Access Compliance Report

Public Rights-of-Way

Intersection ID: 32317	Main Street: BRIDGEVIEW_LN	Cross Street: NEW_PROVIDENCE_LN	Location: SW
ADA ID: 8B5A23561EDD	Ramp Type: BlendTrans1	Initial Pass/Fail: Fail	Overall Compliance: No
Severity Score: 21.25			
Codes/Mitigation Info/Possible Solution		Field Measurements/Component Compliance

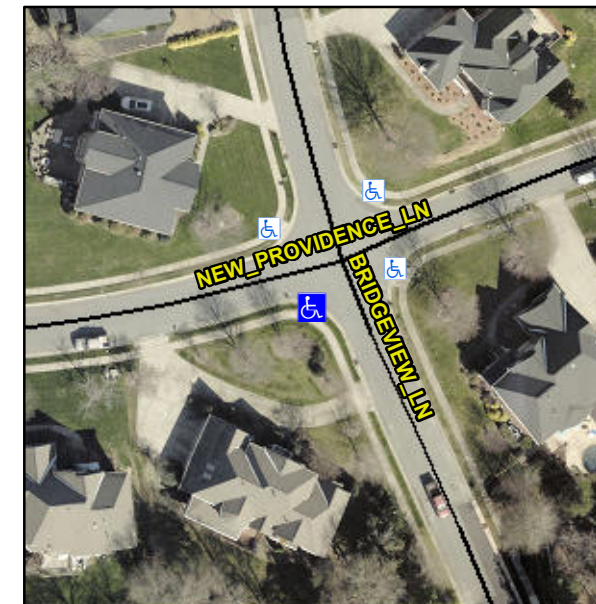
Not Found, R304.5.1, R304.5.3

Compliance	Description	Data	Compliance	Description	Data
N/A	Ramp Length (in)	47.5	Yes	BlendTrans Slope (%)	2.6
No	Ramp Width (in)	44.5	No	BlendTrans XSlope (%)	6.6
N/A	Flare Type LT	N/A	N/A	Flare Type RT	N/A
N/A	Flare Slope LT (%)	N/A	N/A	Flare Slope RT (%)	N/A
N/A	Flare Traversable LT?	N/A	N/A	Flare Traversable RT?	N/A
N/A	Landing Length (in)	N/A	N/A	DWS Provided?	N/A
N/A	Landing Width (in)	N/A	N/A	DWS Contrast?	N/A
N/A	Landing Slope (%)	N/A	N/A	DWS Length (in)	N/A
N/A	Landing X Slope (%)	N/A	N/A	DWS Full Width?	N/A
N/A	Landing Curb? (Y/N)	N/A	N/A	DWS Offset (in)	N/A
N/A	Shared Landing?	N/A			
N/A	Gutter Ponding?	N/A	N/A	Gutter Slope (%)	N/A
N/A	Gutter Lip Ht (in)	N/A	N/A	Gutter X Slope (%)	N/A
N/A	Painted X Walk1?	No	N/A	Painted X Walk2?	No
	X Walk 1 Direction	To NE		X Walk 2 Direction	To N
	X Walk 1 Width (in)	N/A		X Walk 2 Width (in)	N/A
	X Walk 1 Slope (%)	1.4		X Walk 2 Slope (%)	3.9
	X Walk 1 X Slope (%)	6.8		X Walk 2 X Slope (%)	0.2

N/A	Ramp inside XWalk1?	N/A	N/A	Ramp inside XWalk2?	N/A
	Road Slope (%)	6.0		Clear Space?	N/A
	Road X Slope (%)	4.6	N/A	Clear Space to XWalk (in)	N/A
N/A	Any Obstructions?	N/A	N/A	Storm Grate/Utility Hazard?	N/A
	Obstruction Type			Storm Grate/Utility Type	
		N/A			N/A
			Yes	Surface Condition? (G/P)	Good
			No	Curb Slope (%)	8.2

Remove & Replace Curb Ramp With Two New Directional Ramps or Equivalent.
